**TOWN OF BLACKSTONE, MASSACHUSETTS
WATER TREATMENT PLANT
CONTRACT 2020-1, DWSRF 6686**

ADDENDUM NO. 1

E402

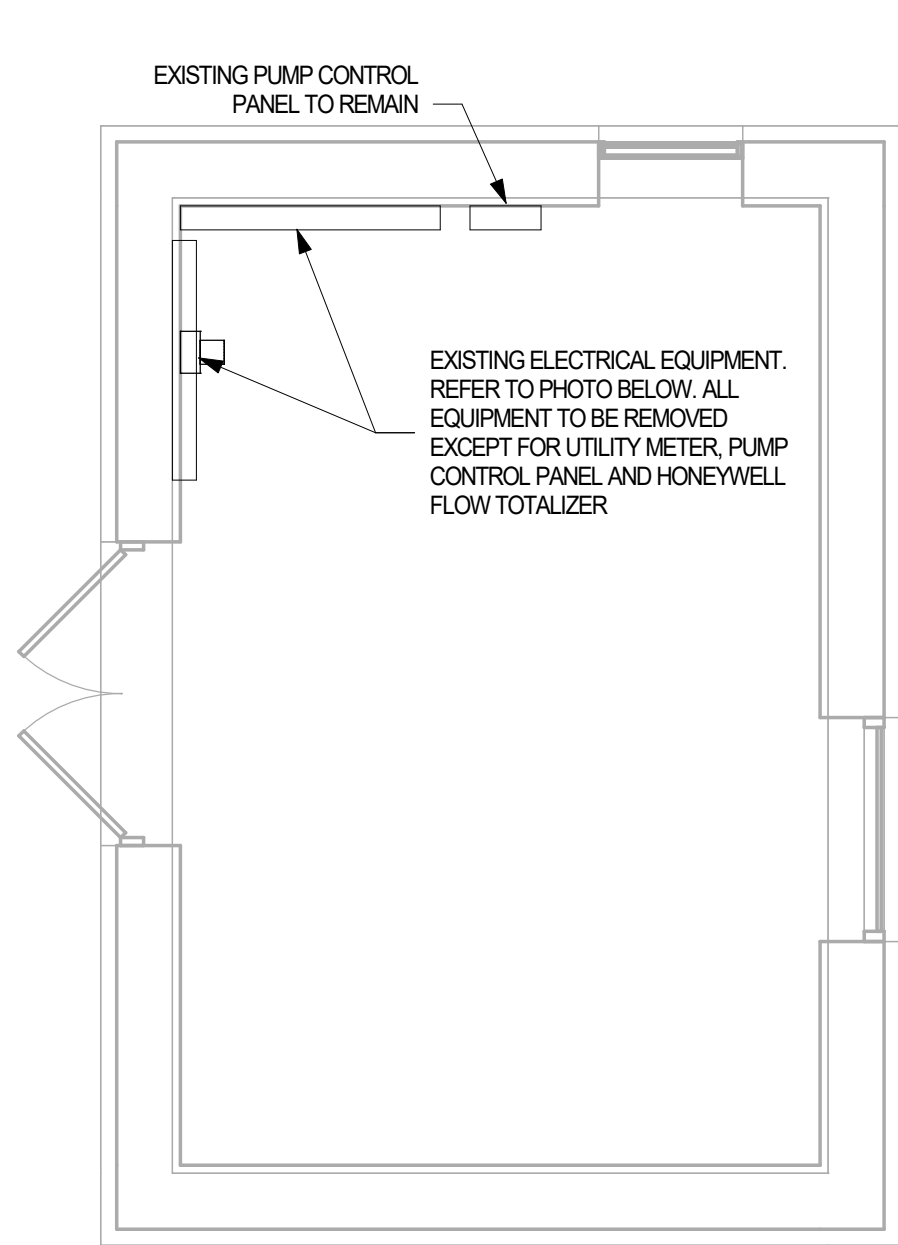
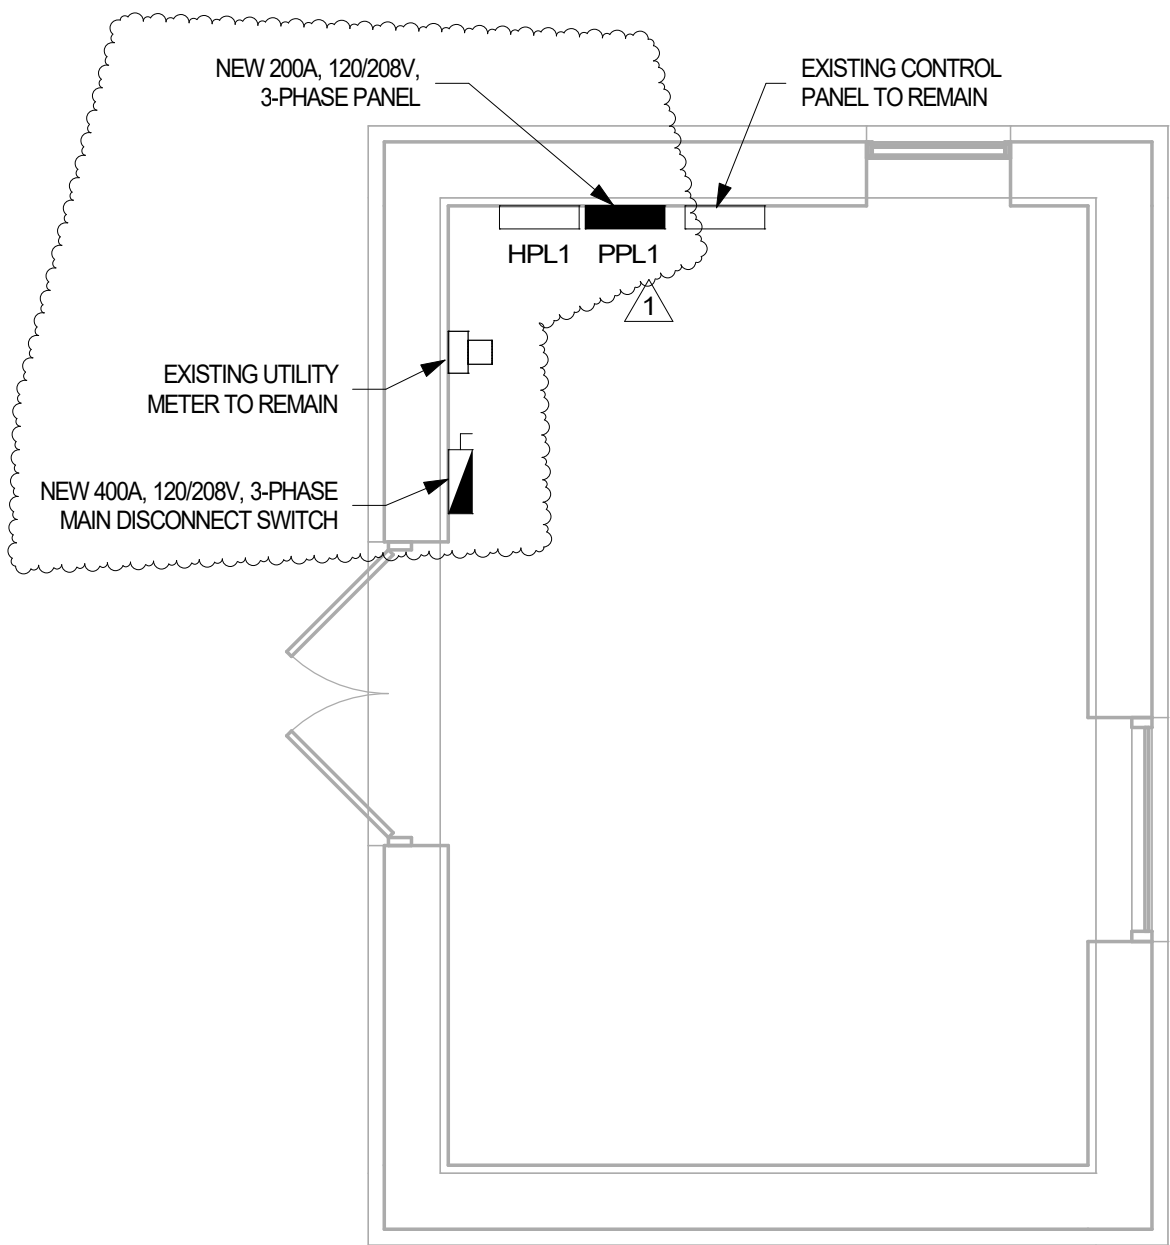
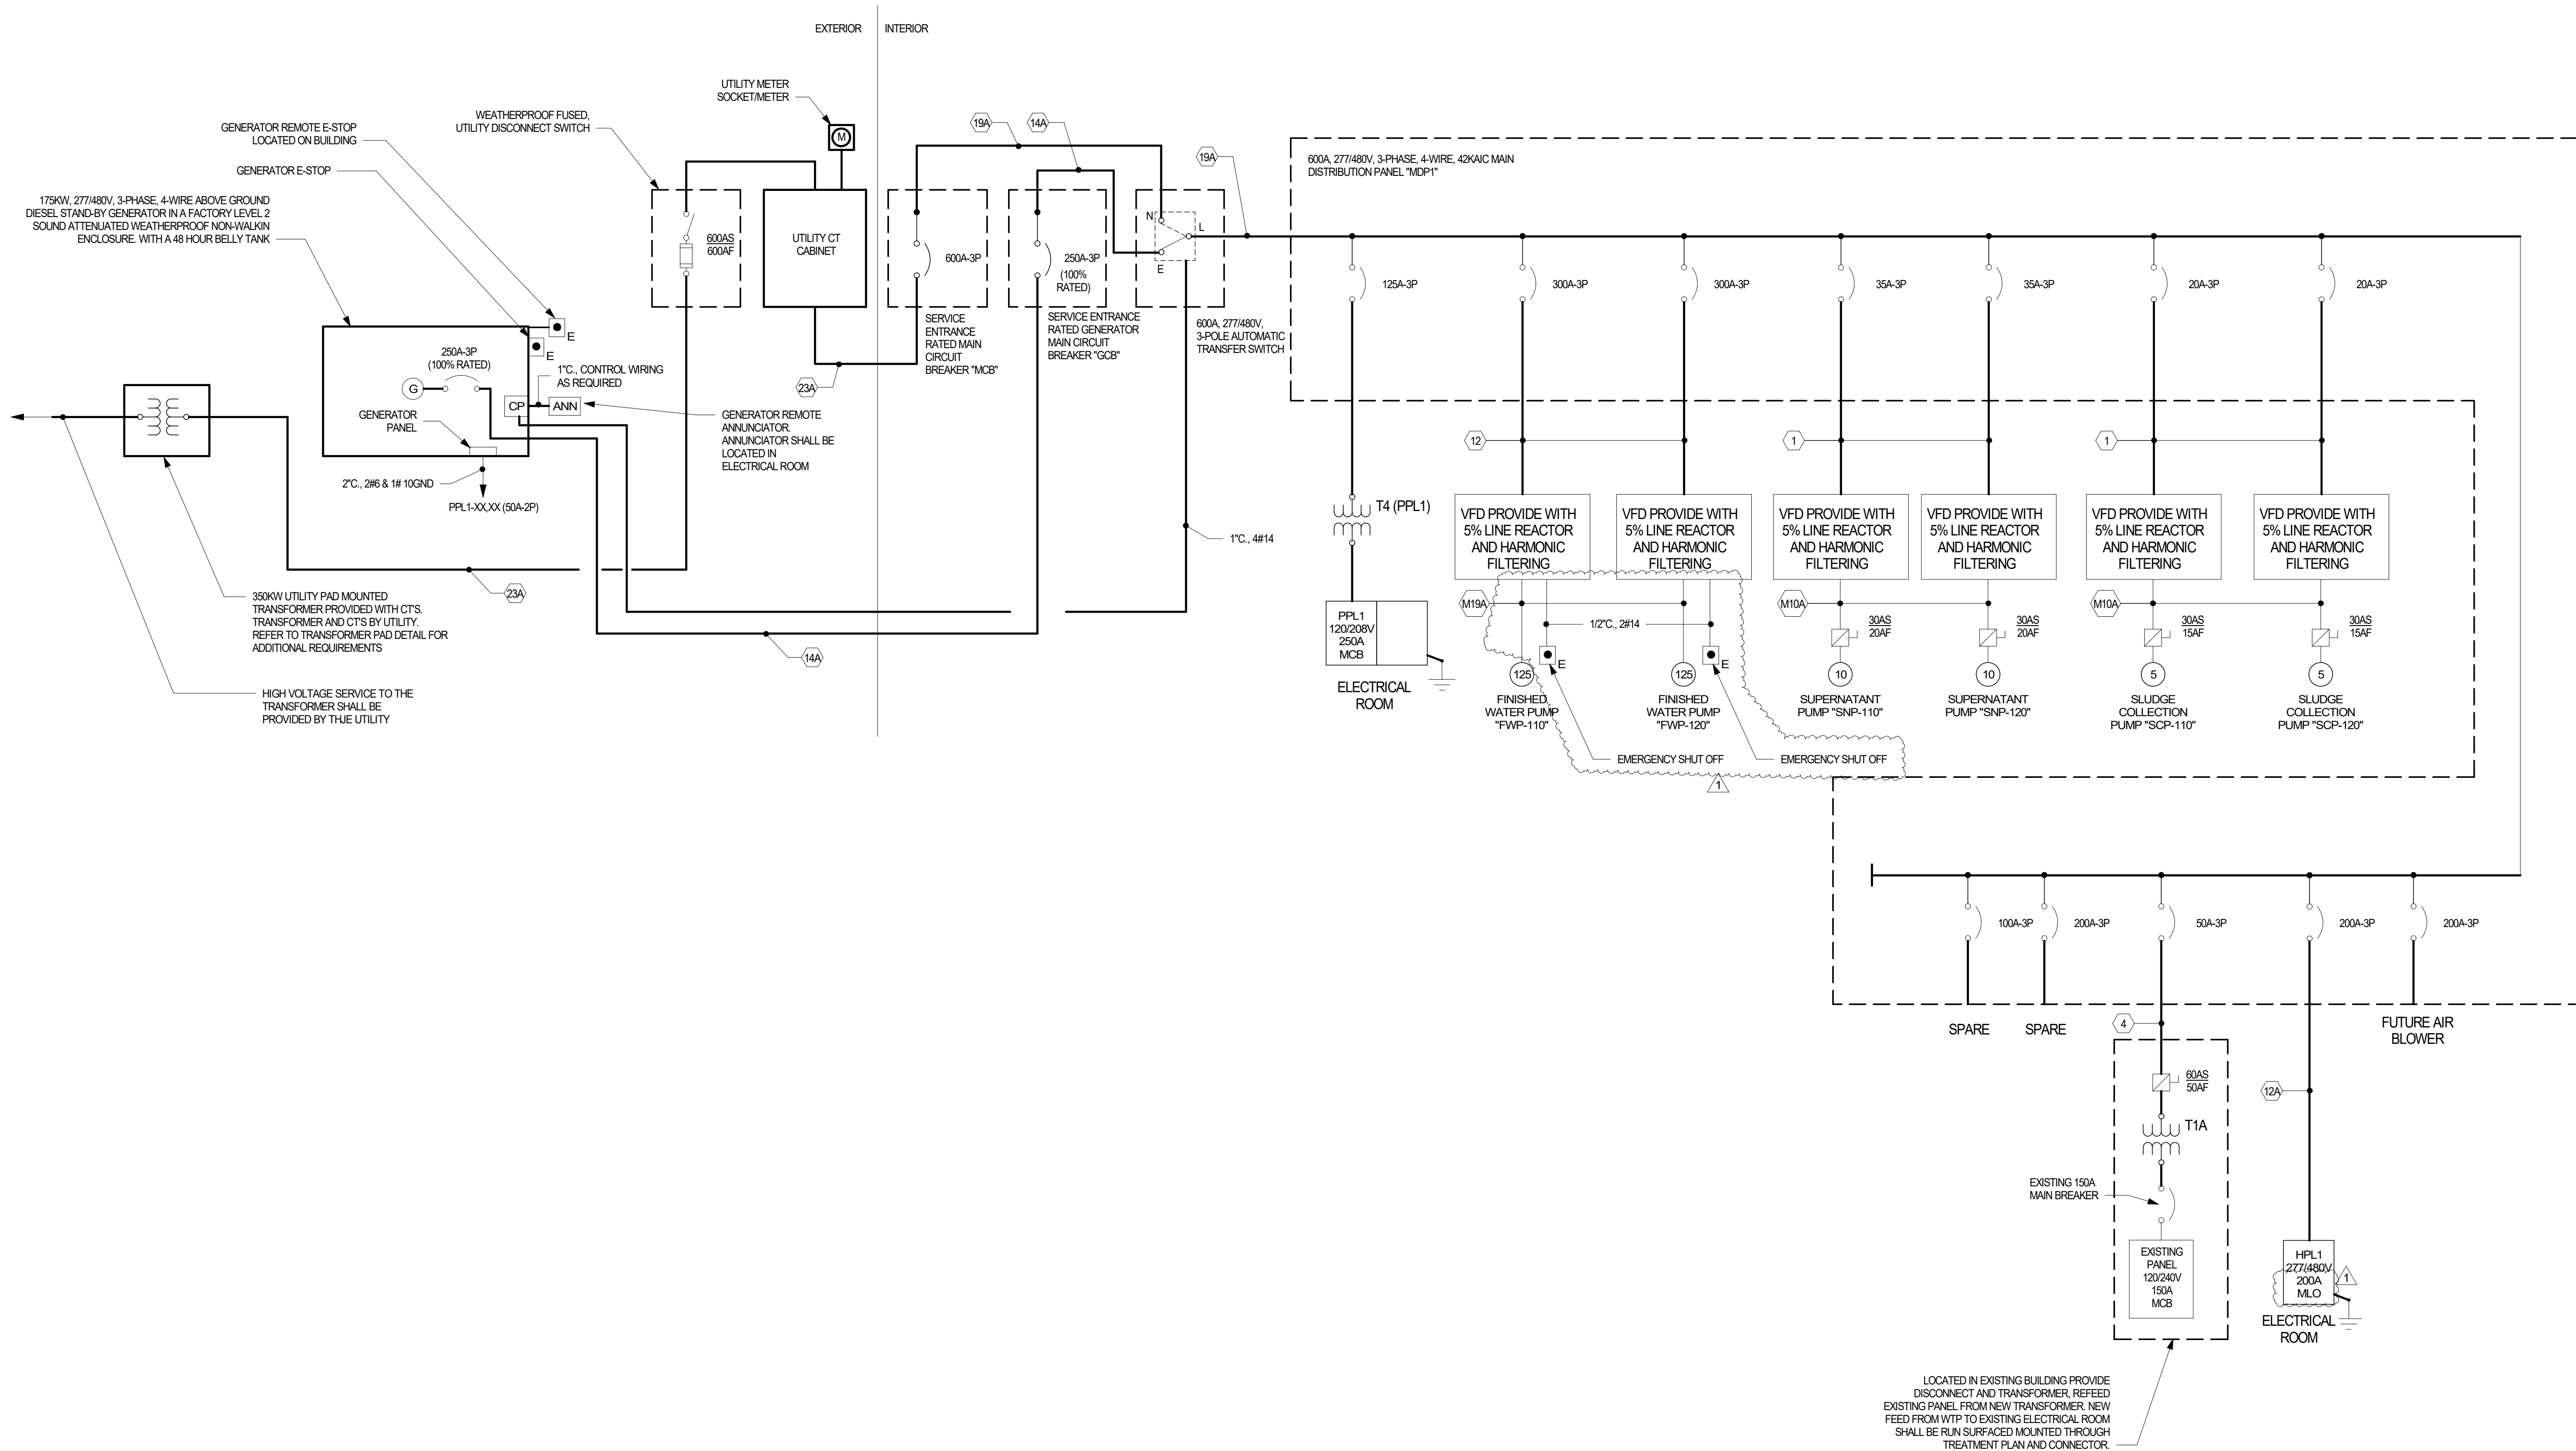
1. Delete “Sheet E402” in its entirety and replace with attached “Sheet E402 – Electrical Well Plans Sheet II – Alternate No. 1”.

Question: Should any of the electrical equipment at Well 4 be maintained?

Answer: Contractor shall maintain the Honeywell Flow Totalizer as this is currently providing the well station’s flow and will continue to do such in the future.
